SOAH DOCKET NO. 582-22-0585
TCEQ DOCKET NO. 2021-1001-MWD

APPLICATION BY
CITY OF GRANBURY,
FOR TPDES PERMIT NO.
WQ0015821001

PREFILED TESTIMONY

WOODY FROSSARD

6
7 **Figure 1: Lake Granbury water surface elevation 2010 - 2021**

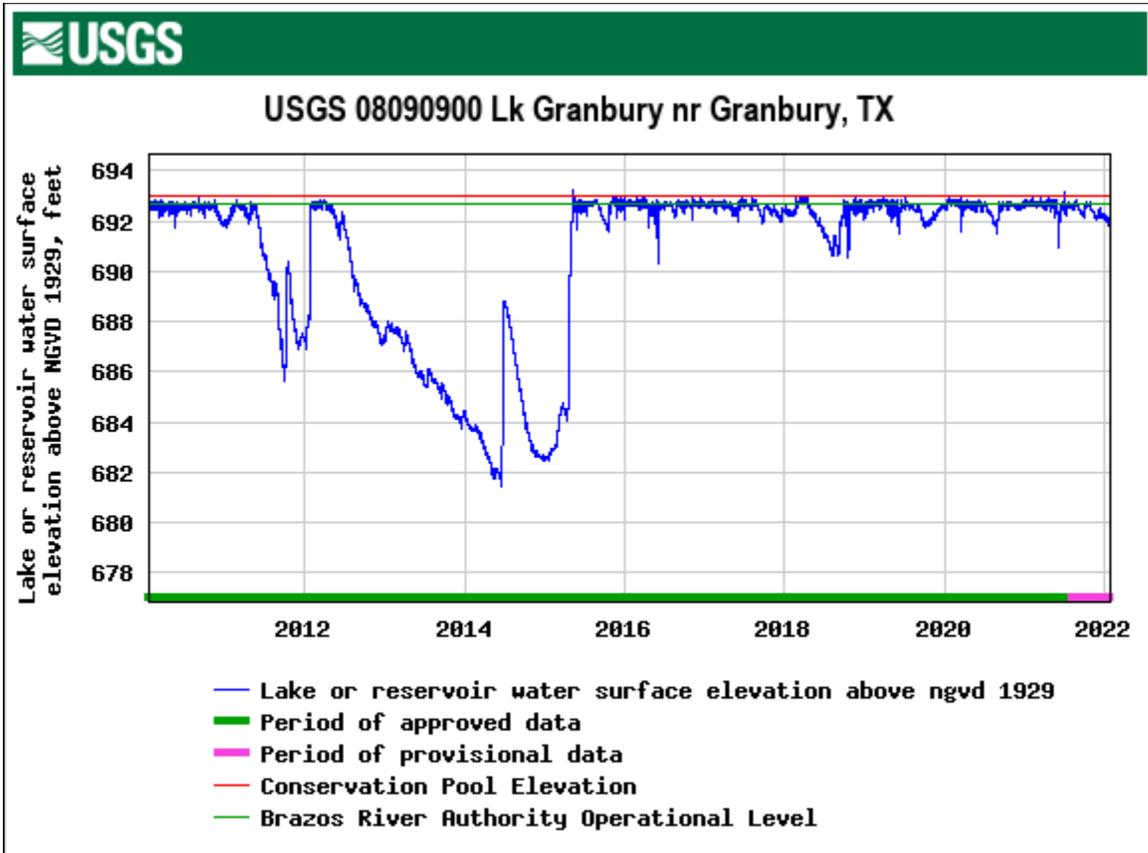
1 lower limits until the DO was either met or the determination that the receiving waters
2 could not assimilate a discharge of 2 mgd and the discharge would not be permitted.
3 I also question whether the TCEQ chose the most critical period for Rucker Creek and
4 Rucker Creek Cove. As can be seen by Figure 1, I downloaded the USGS Lake Granbury
5 water surface elevation for the past 10 years.

8 As this shows, during 2013, the reservoir reached a low of slightly below 682 feet above
9 mean sea level (msl). The conservation elevation of Lake Granbury is approximately 693
10 msl. During this period of time, the reservoir was reduced by approximately 11 feet.
11 Utilizing the data provided by the Executive Director's Dissolved Oxygen Modeling
12 Permit Review Checklist (DO Modeling Checklist) the area utilized for determining the

1 DO standard in Rucker Creek Cove averages approximately 6 feet or less in depth. So, for
2 the lowest period of time, most of the area used by the TCEQ for analysis was dry. Over
3 the period of July 2012 to May 2015, the reservoir average was approximately 6 feet low.
4 So, for a period of 3 years, Rucker Creek and the area utilized by TCEQ for determining
5 impacts to receiving waters was dry. This is the reason I believe the most critical period
6 was not evaluated.
